Report / decision to determine notification of a resource consent application

Application Number:	RMA/2019/1330
Applicant:	Collets Corner Limited
Site address:	25 Oxford Street and 3, 5, 7 and 9 London Street
Site area:	518m ² and 455m ²
Legal Description:	Lot 1 DP 13544 and Pt Sec 31 Lyttelton Town
Zoning:	Commercial Banks Peninsula Zone
Overlays and map notations:	Liquefaction Management Area (LMA); Banks Peninsula District Plan Coastal Hazards; Coastal Environment; Ngā Tūranga Tūpuna (65, Ōhinehou (Lyttelton) settlement and port, listed in Appendix 9.5.6.3 Table 3: Ngā Tūranga Tūpuna); and Hill Waterway – Oxford Street Drain
Activity Status:	Discretionary
Application:	New three-storey building containing a health spa, restaurant, gymnasium, offices, retail activity and 26 residential units or guest accommodation

To: Shona Jowett, Planner
From: David Hattam, Senior Urban Designer
Date: 24 October 2019
Re: RMA/2019/1330 – 25 Oxford St and 3-9 London Street (Collets Corner) – Urban Design Assessment for Notification Decision.

Figure 1 Inner survey area outlined in blue, and the wider survey area outlined in black

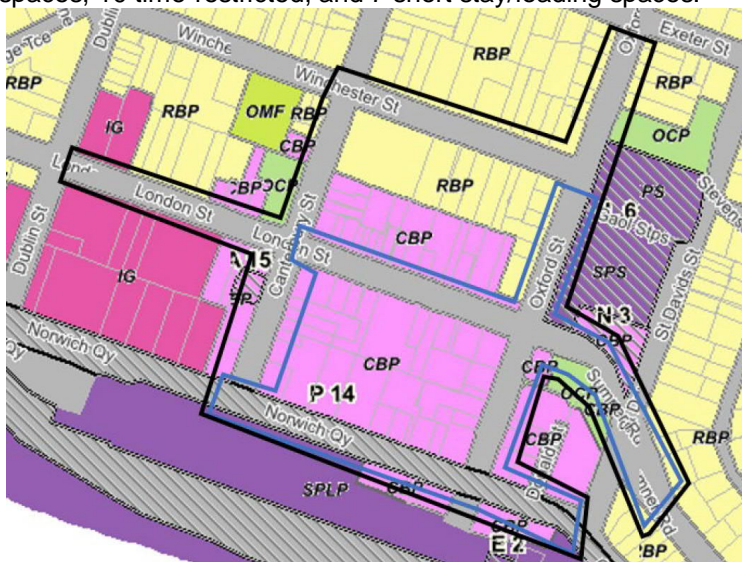
- Six parking spaces provided on-site falls well short of the District Plan requirement; and
- Parking availability in an inner survey area (shown at **Figure 1** below) was found to be 31 spaces at peak demand times (the time when there was the least availability of on-street parking). Availability comprised 21 unrestricted spaces, 10 time-restricted, and 7 short stay/loading spaces.

The findings of the ITA mean that at the busiest surveyed time the on-street parking in the immediate area will be at full capacity, with the possibility of some existing demand being displaced into the wider survey area, and some of the demand generated by the proposal using parking spaces in the wider area. Peak time in the survey was at 12:30pm Thursday 6 December. There were other surveys undertaken on other days and times but this was the busiest.

Figure 2 Ground floor plan, points to be secured to mitigate safety effect marked in red

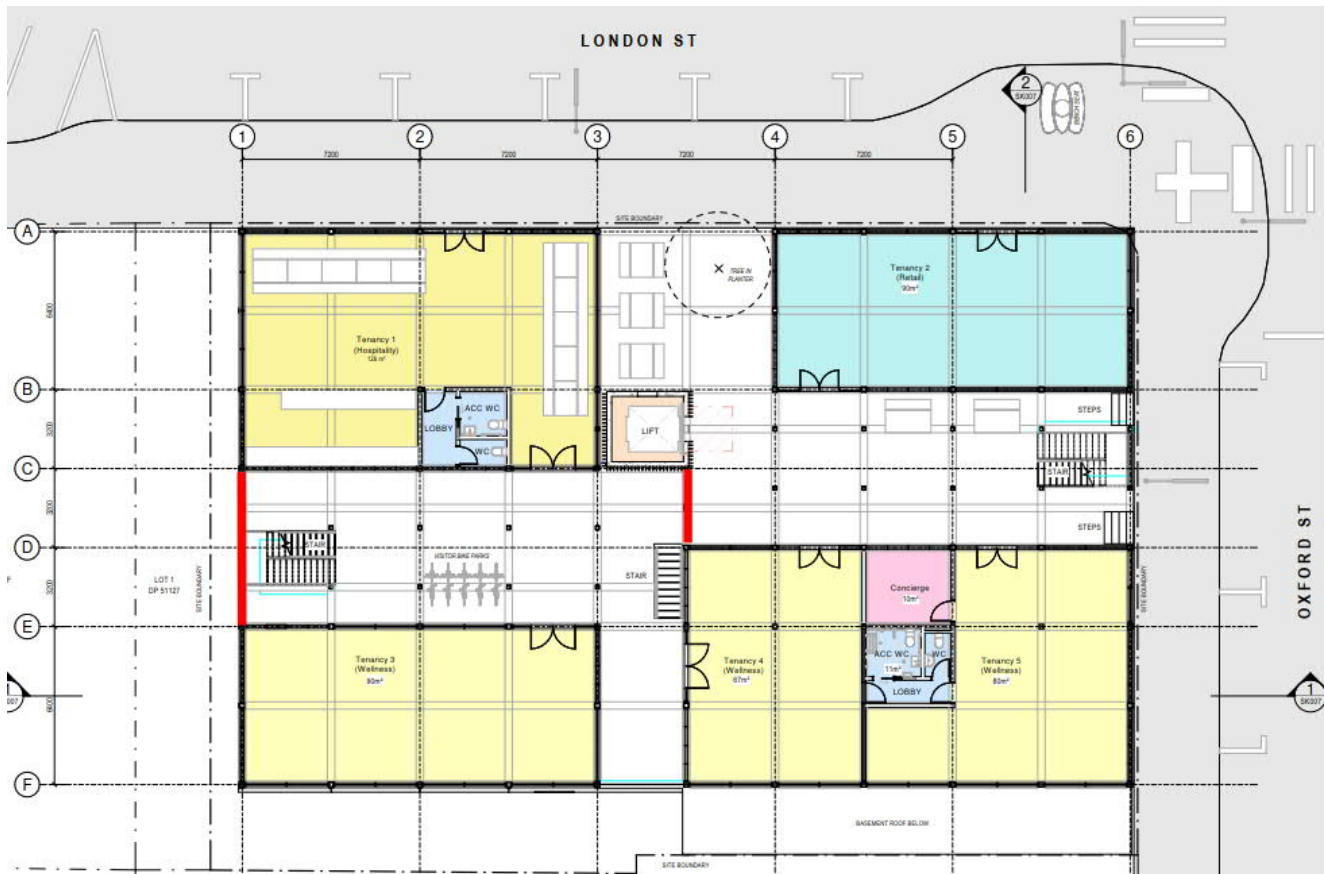
The applicant has volunteered conditions of consent to place gates to close the higher risk areas to the public at night (a consent condition is offered to allow the applicant to minimise the risk of entrapment in the next design phase and for this design solution to be certified by Council before construction). The applicant has also offered a condition of consent requiring a lighting plan acceptable to the Council be provided post-consent (a lighting plan would demonstrate adequate lighting for safety and security purposes). Mr Hattam agrees this approach could mitigate any safety concerns for the public.

I consider that a condition requiring closing off of potential entrapment spaces would mitigate safety concerns. However this was discussed at a meeting with the applicant and subsequent information confirmed only the stairs and lift would be secured, rather than a larger area of the ground floor which was suggested as a solution at the meeting. If the larger area can be secured (as illustrated in **Figure 2** below) then I consider the safety effects of the proposal would be less than minor, but if not, I consider effects would be minor – though this is finely balanced for me and they could come close to being more than minor.
